Product Revision/Upgrade Instructions

Product Type	HD2200 and HD6200 when Down-converter option is fitted		
Revision Type	Installation of OPI card		
Version Change	From	N/A	To N/A
Date	260701		
Issued By	Steve Hall		
Installed By	Company		
	Name		Date
Reason			
Unit Serial Number			
Customer Name			
Customer Address			
Telephone Number		Fax Number

Appendix 1 Hardware Modification Instructions

Assembly	SAADA HD6HIO1Y	MOD	3 of 3
PCB	RMPDA HD6HIO1Y		
Date	07/03/01		
Production Engineer	Steve Hall		
Designer	James Walker		
ECR Nos.

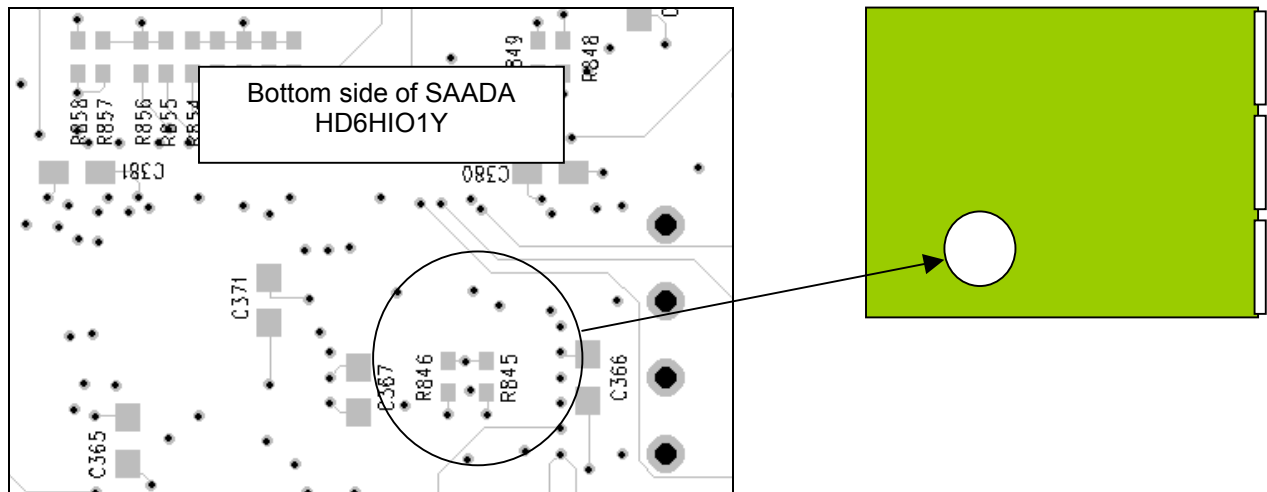
1. Access underside of assembly SAADA HD6HIO1Y
2. PLI Check Only.
Note: Boards ML3 & onwards have changes corrected by a PLI update.
3. R846 is Not fitted.
4. R845 is now 3k3 0603 (E6 3K3-0603) resistor

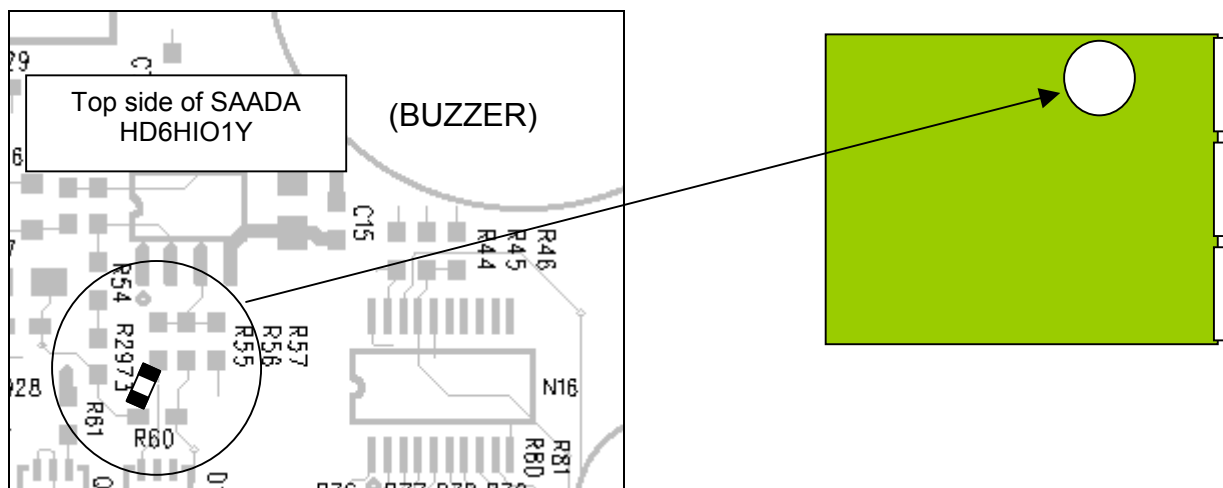
5. Solder a 75ohm 0603 (E6 75-0603) resistor between R55 and R60, shown below.
